**ADDENDUM NO. 1  
EN-322-09  
INDIANA TRANSPORTATION MUSEUM  
SITE REMEDIATION  
FOREST PARK  
825 PARK DRIVE  
NOBLESVILLE, INDIANA**

January 31, 2022

**Item 1 - CIB – Remove/Replace Special Provisions**

**Item 2 – Remove/Replace Plan Sheets**

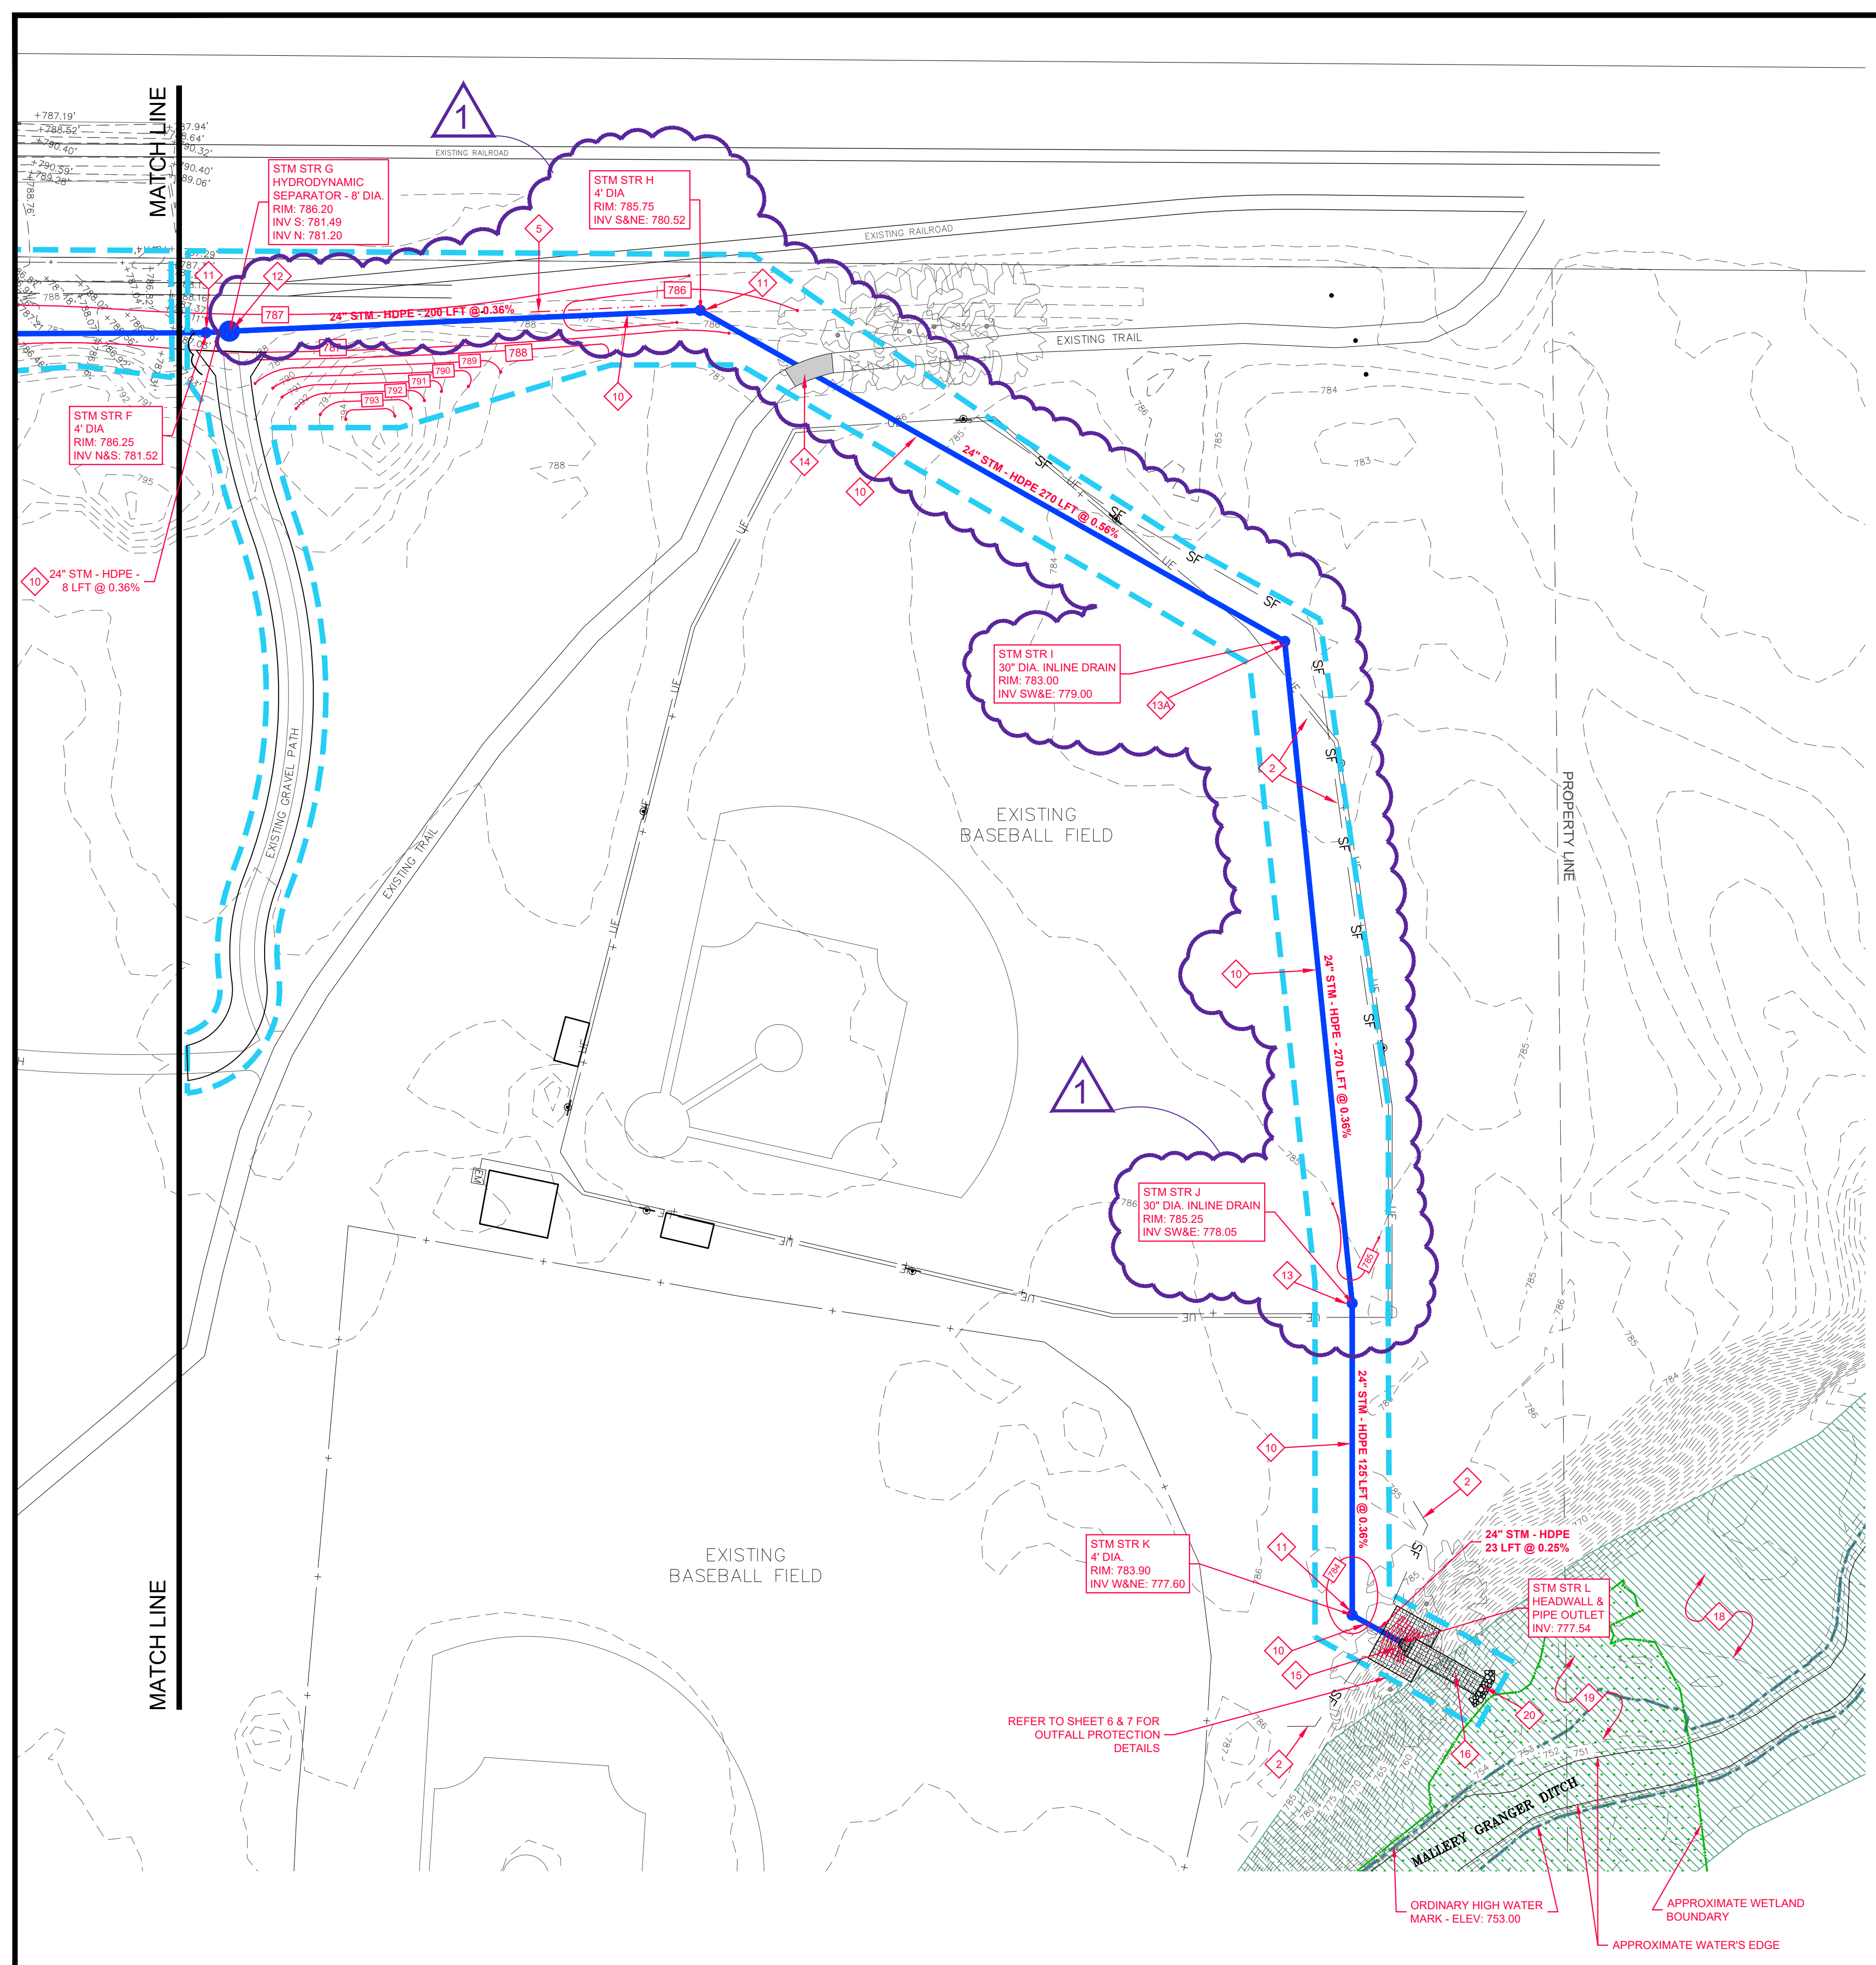
- Sheet 5, On-Site Excavation Plan:  
Area of excavation has been modified to exclude area on the south side of the Site north of Hobbs Station as shown on reissued Sheet 4. The identified area is to be excavated by others.
- Sheet 6, On-Site Grading & Drainage Plan:  
The Storm Pipe from Structure B to C will increase from 12" to 15" as shown on reissued Sheet 6. Invert elevations will be maintained the same.
- Sheet 7, Off-Site Grading & Drainage Plan:  
Structures No. H, No. I and No. J shall be relocated as shown in reissued Sheet 7.
- Sheet 10, On-Site Improvement Plan & Details  
Detail for new 18' Wide, Double Swing Gate as shown on reissued Sheet 7

Sheet 11  
**Off-Site Improvement Plan & Details**

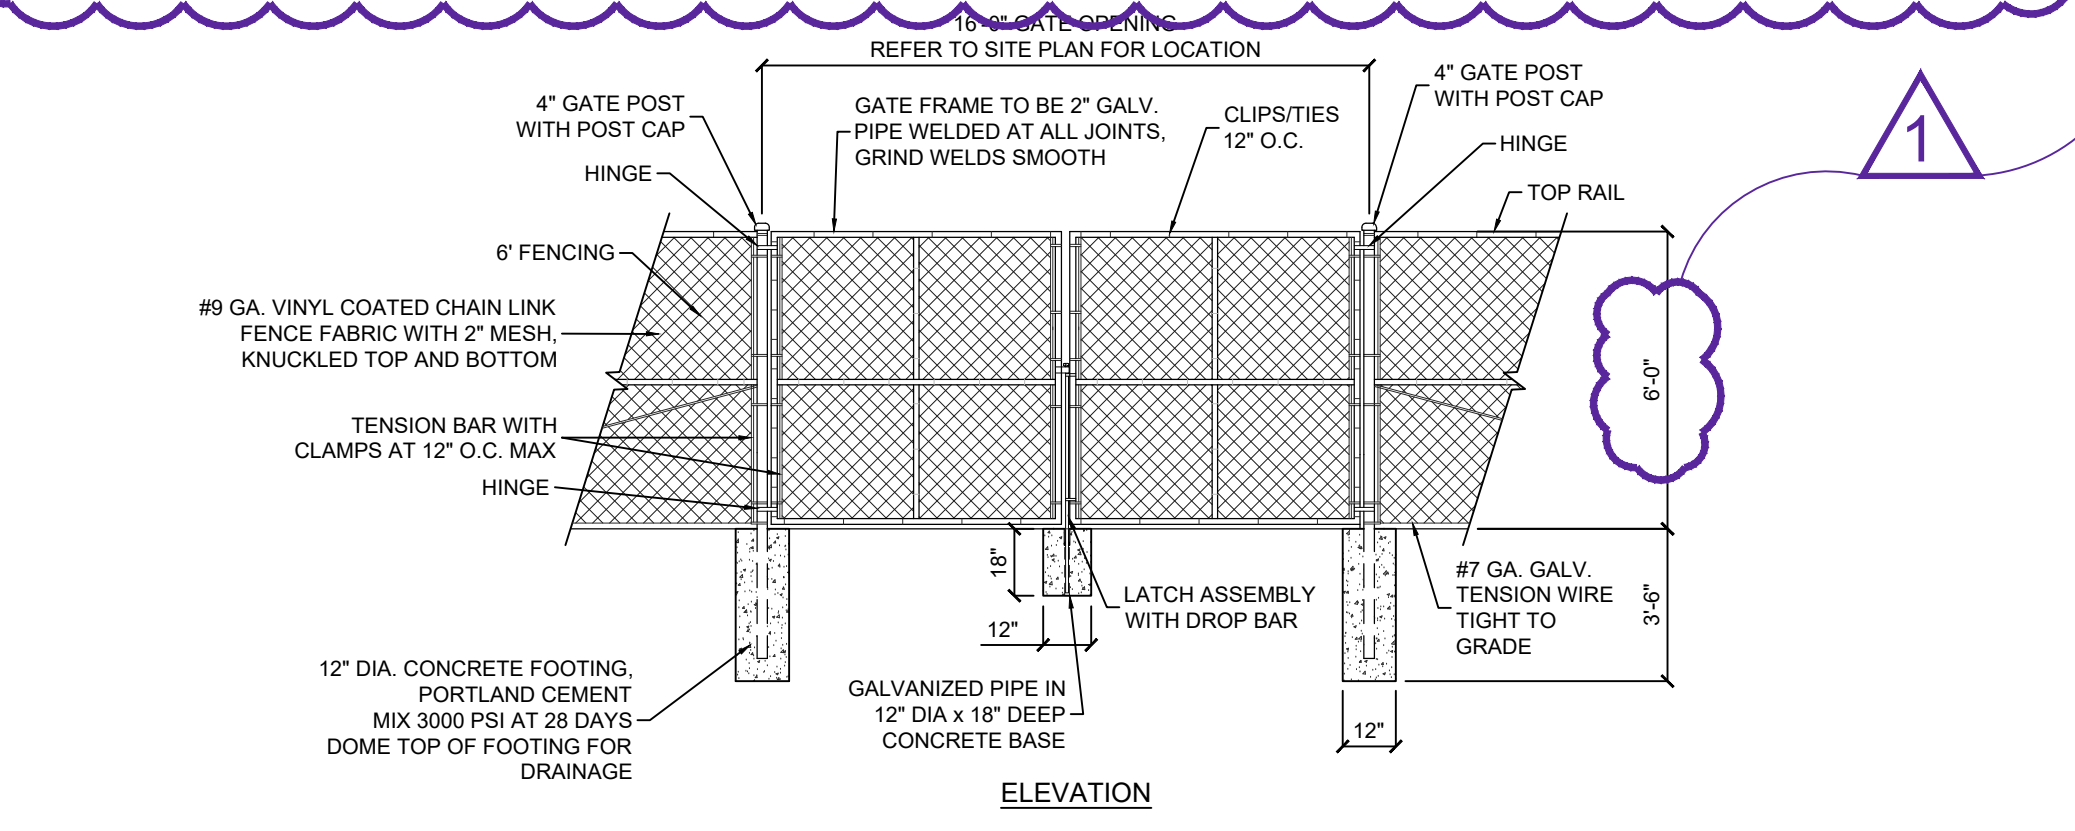
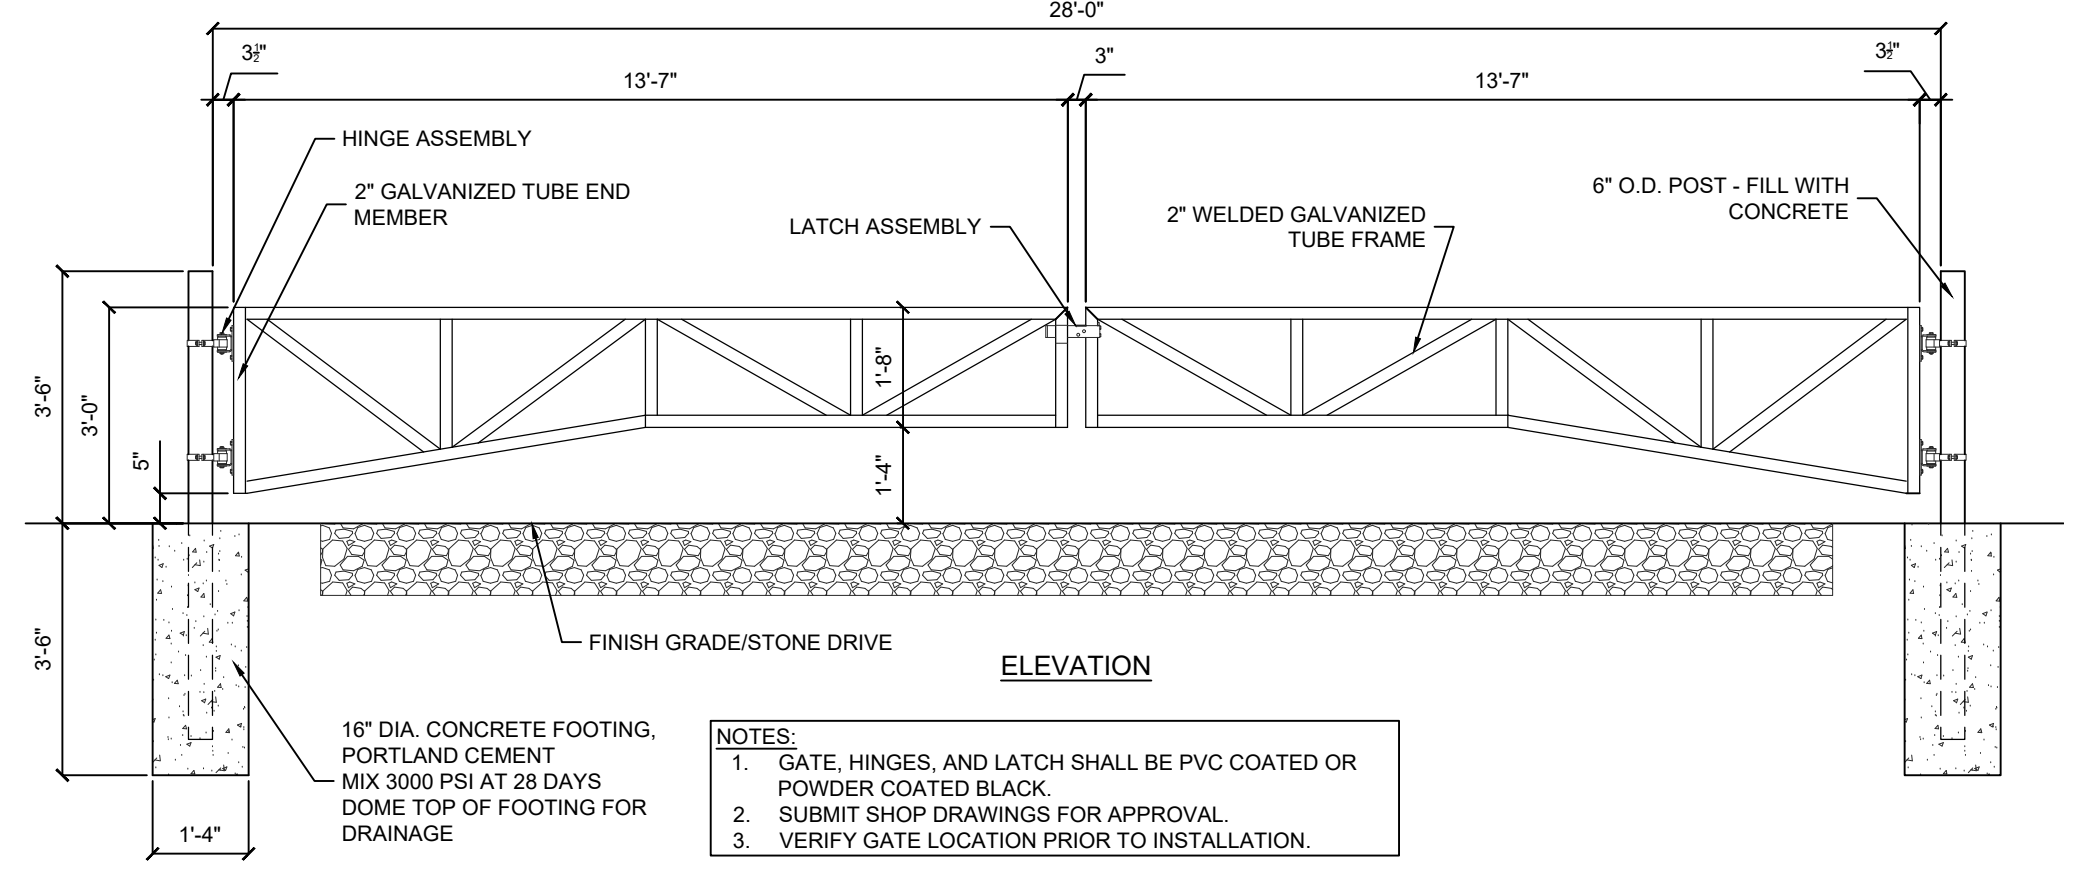
- Sheet 11, Off-Site Improvement Plan & Details:  
Increase thickness of concrete patch from 4" to 6"  
Revised detail for fence height from 8' to 6'
